Service Bulletin

ISSUE NO.:CRT03-006

1. MODEL(S) AFFECTED : FE750(A) , FE750(B) , FE750(R) , FE750(A) (C) , FE750VE(B) , FE950(A) , FE950(B) , FE950(R) , FE1250(A) , FE1250(B) , FE1250(R)

2. SUBJECT:Countermeasure of R556 broken (Revise of CRT02-002)

[Procedure D501_R556]

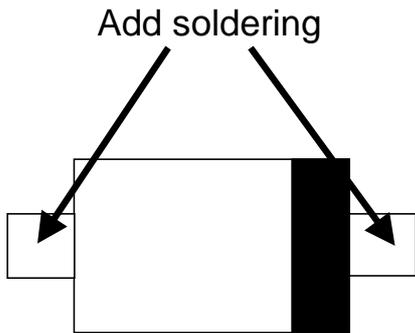
(1) Add soldering on lead of D501.

- (1) Add solder part of D501.
Refer to the documents of "Procedure D501_R556".
- (2) Exchange R556 from 1/4 watt resister to 1/2 watt resister.
Refer to the documents of "Procedure D501_R556".
- (3) Replace IC541
Refer to the documents of "Procedure IC541".
- ~~(4) Replace IC491, IC854
—Refer to the documents of "Procedure IC491_IC851"—~~
- (4) Add thermal conductive sheet to IC541 for radiate heat of IC
Refer to the documents of "Procedure IC541 additional operation".

(2) Exchange R556 from 1/4 watt resistor to 1/2 watt resistor.

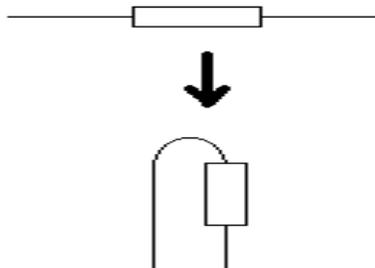
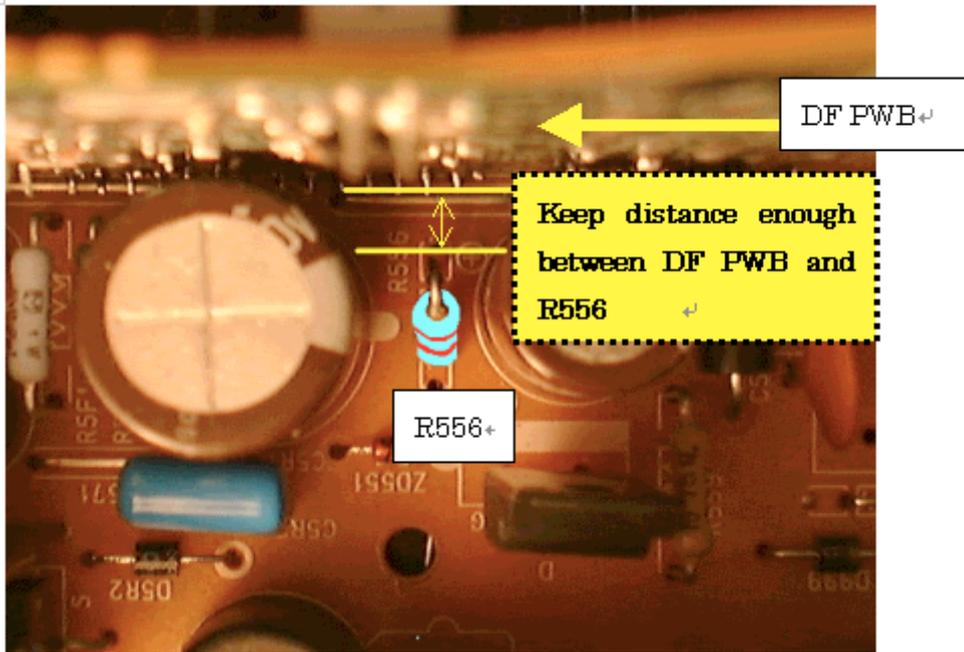
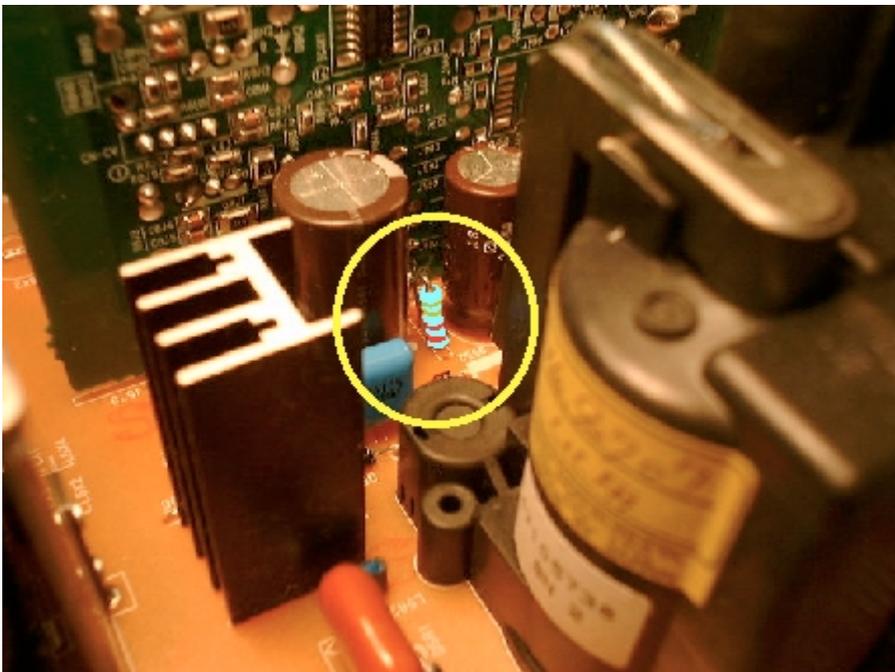
a) To apply the read forming as follow.

b) To insert the formed resistor using pitch 5 mm holes as attached.

(3) Replace IC541

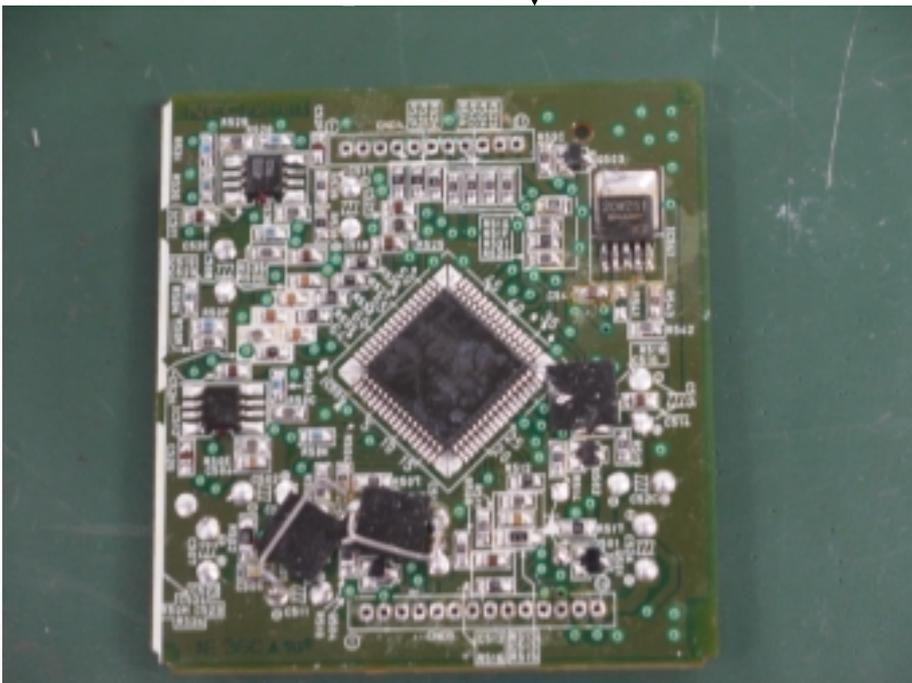
a) De-solder SHIELDING-CASE(2 points) to take it off OSC-PWB.

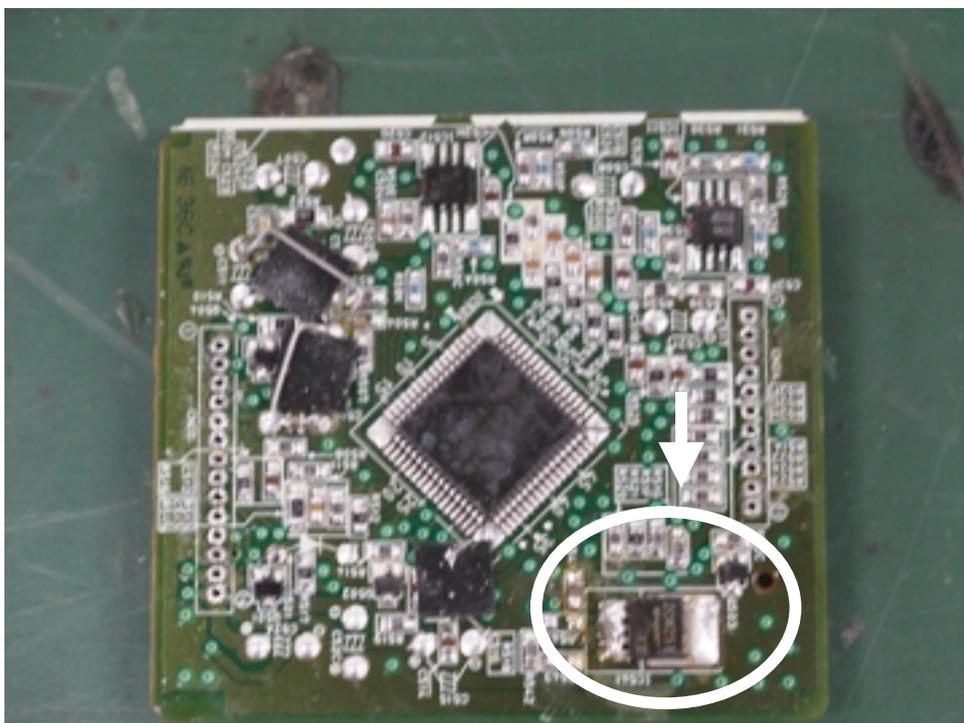
b) Supply additional solder to IC541's 5 leads to make solder bridge.

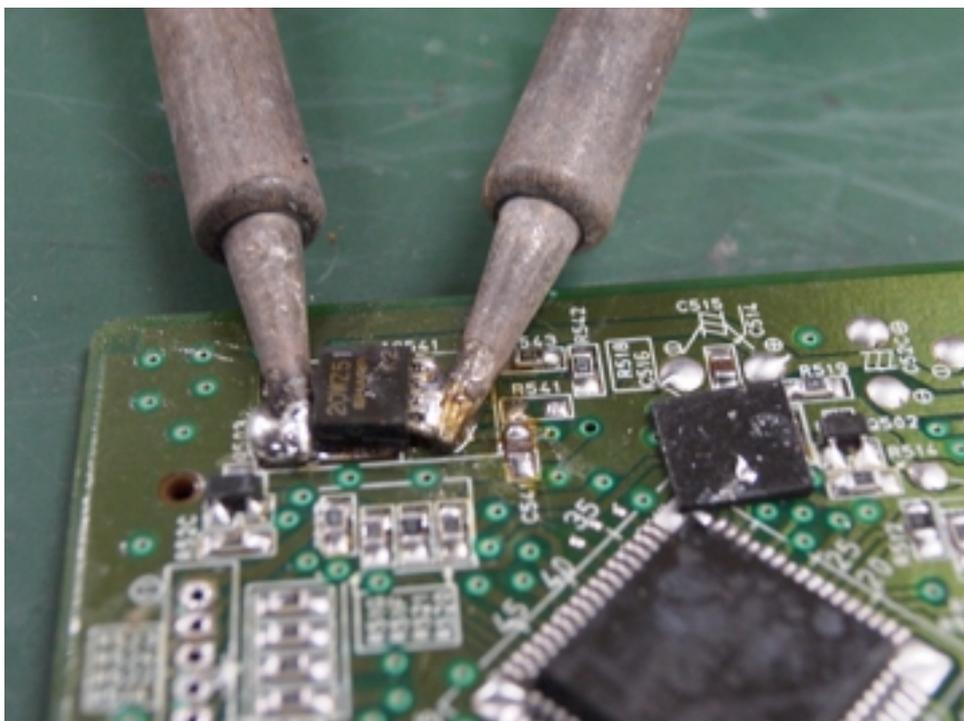
c) Heat IC541's 5 leads and head of body (fin) at the same time with 2 soldering irons. When the solder is melted, take IC541 with pliers. Please do not heat it to excess. If it's too much to heat, soldering pad will be lifted.

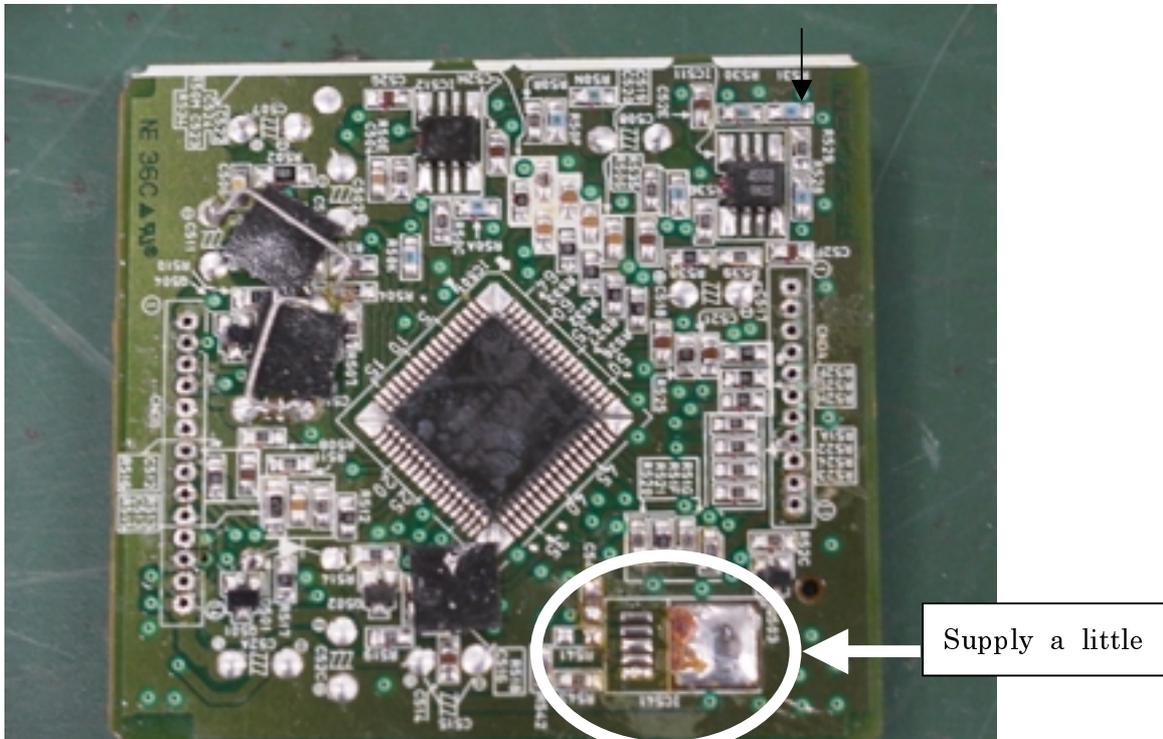
d) Clean soldering pad on OSC-PWB with de-soldering tool, and To connect head of body(fin) temporarily, Supply a little solder to soldering pad.

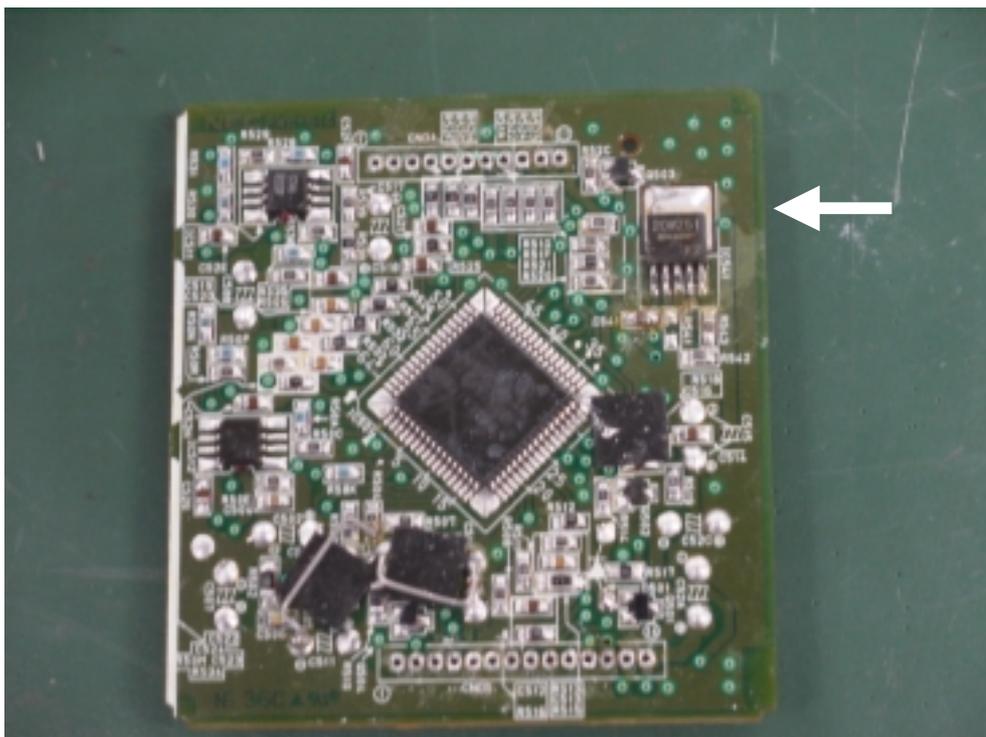
e) Place new IC541 on soldering pad and solder head of body(fin).
Soldering condition) Temp : 320 , Time : Maximum 5 sec

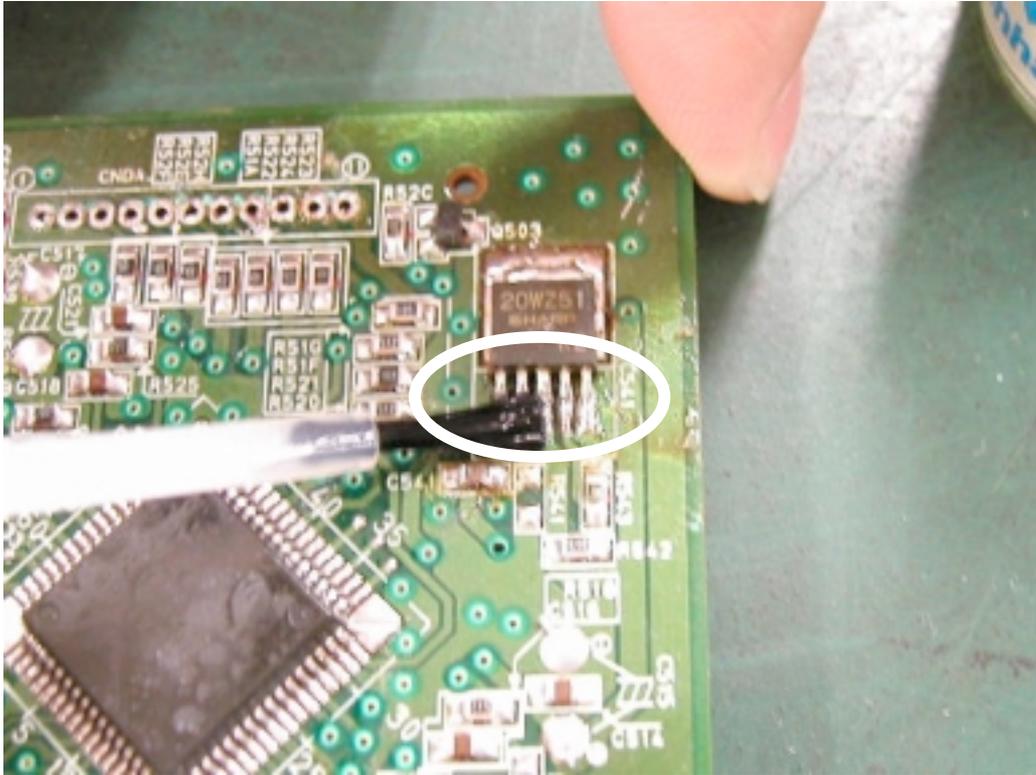
- f) Supply the flux to leads area and solder each leads and head of body.
Soldering condition) Temp : 320 , Time : Maximum 5 sec for each lead

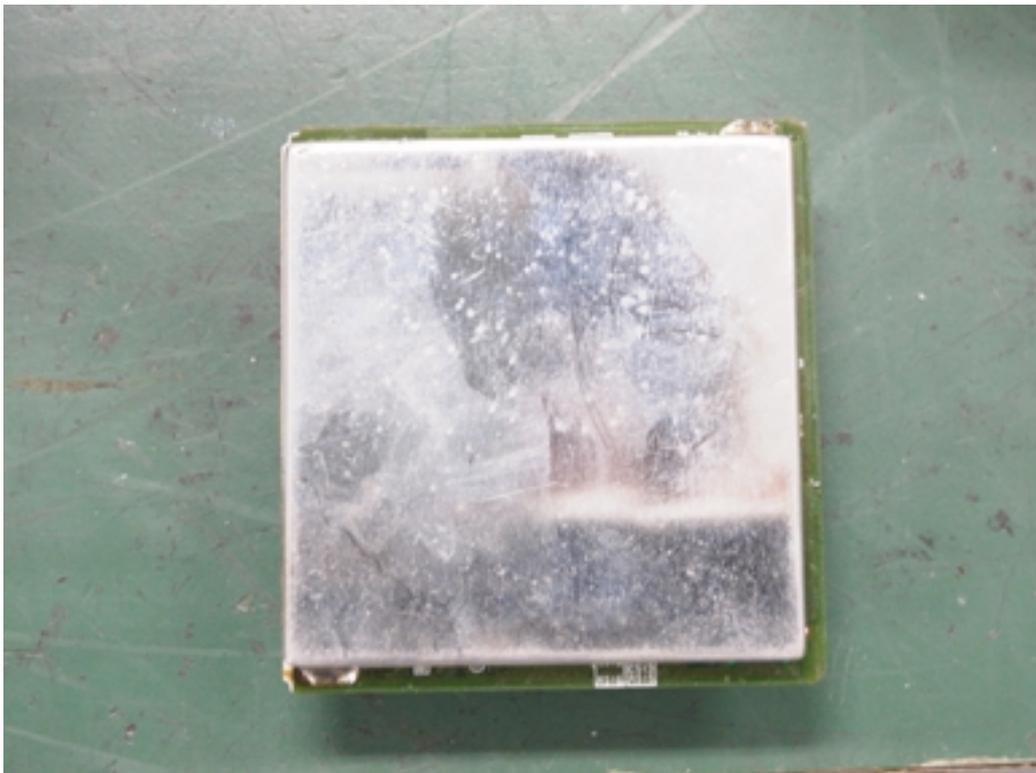
- g) Put SHIELDING-CASE on OSC-PWB and solder it(2 ponints).

The way of putting a sheet

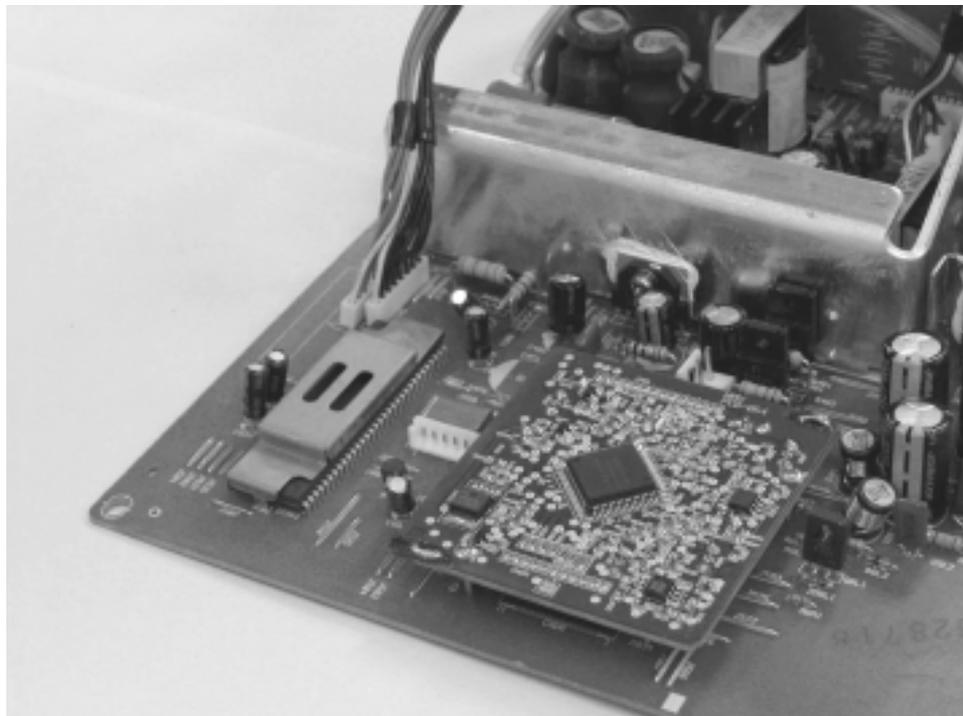
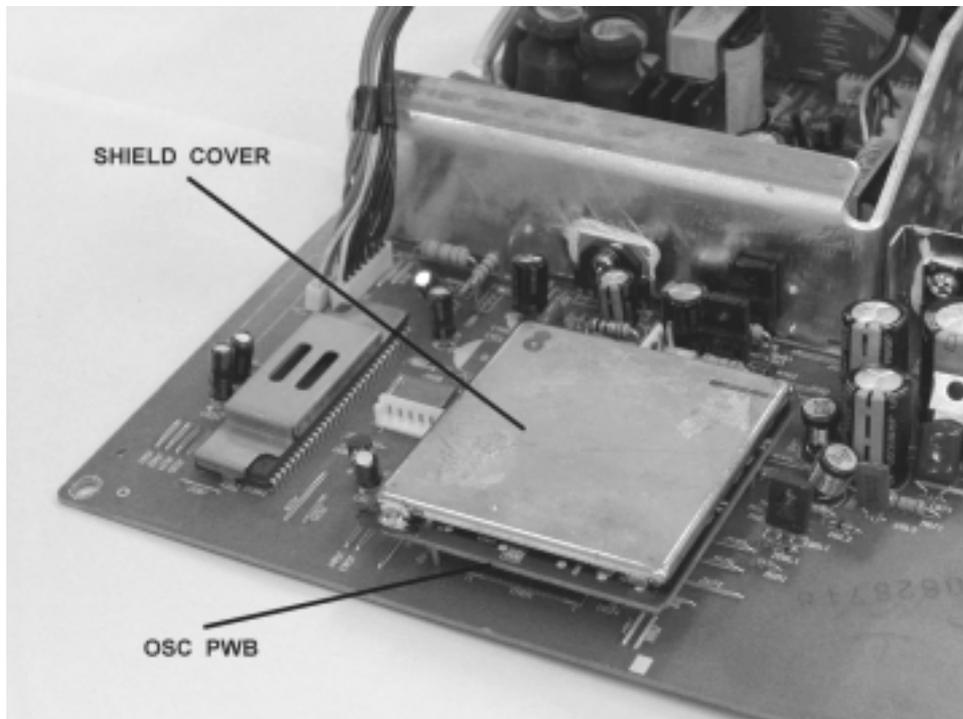
1 . A shield cover is removed from OSC PWB.

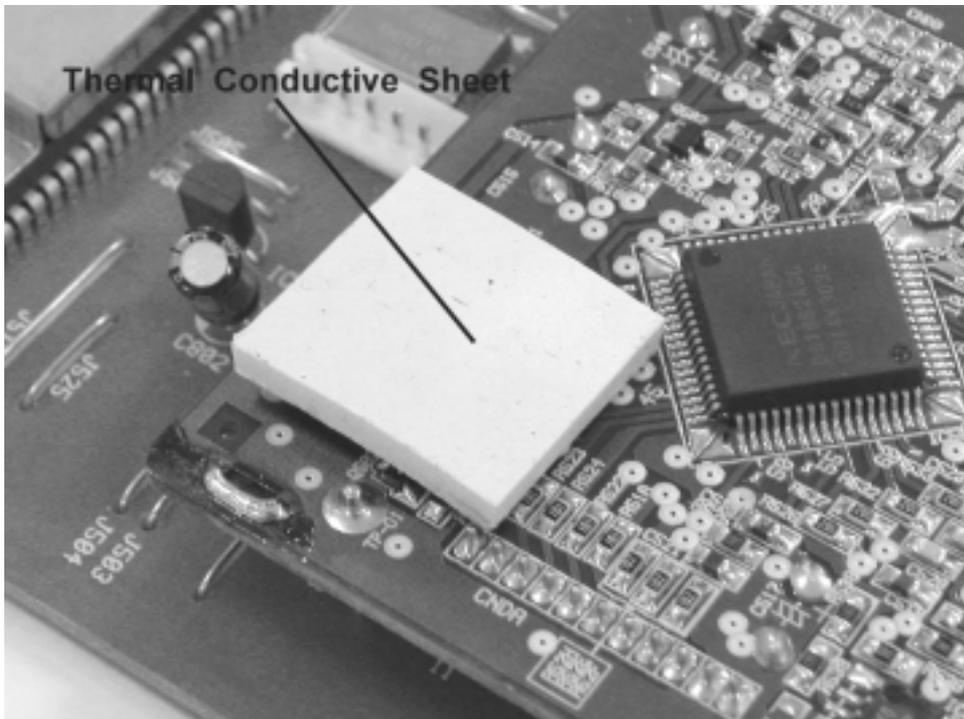
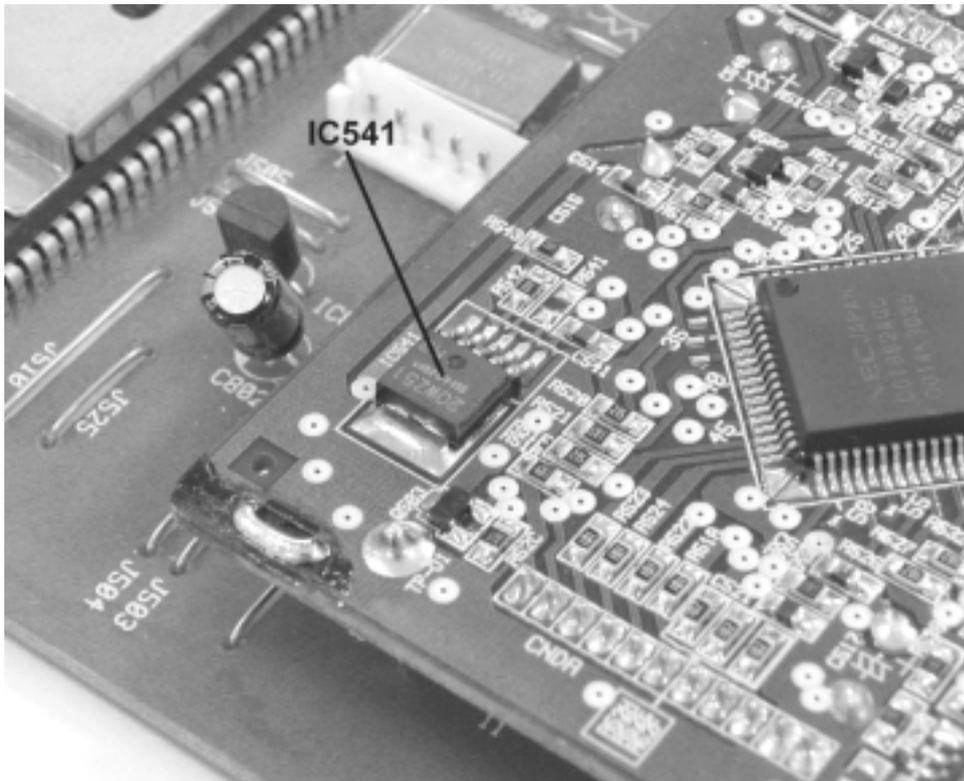
2 . A thermal conductive sheet is placed on IC541

**The purpose to put a sheet is for IC541 to radiate.
So, Please put this sheet to touch IC541 and a shield cover well.**

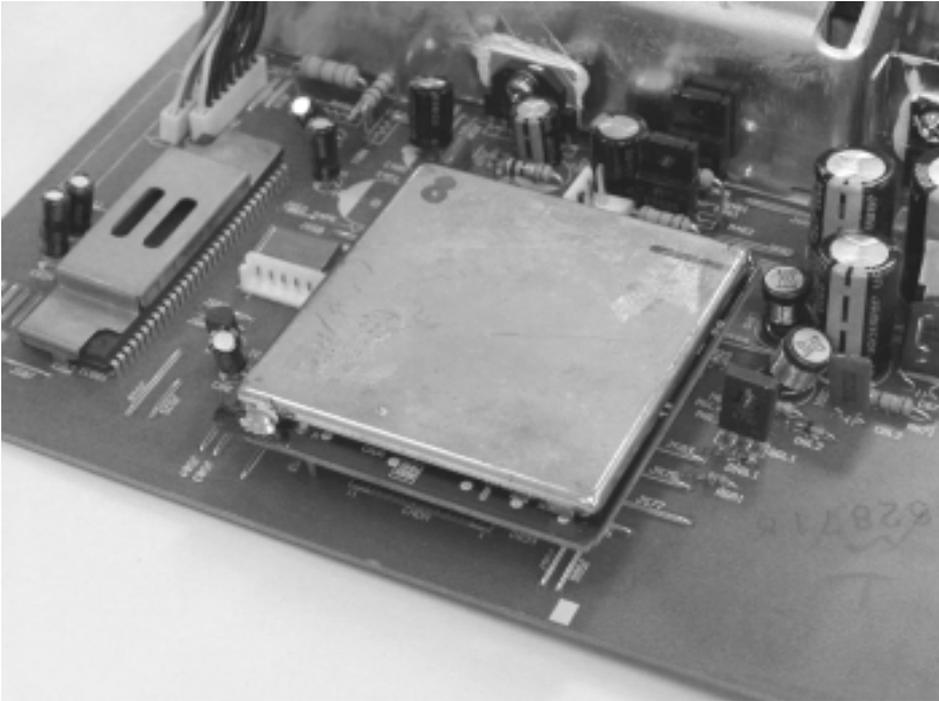
3. A shield cover is soldered to the OSC PWB.
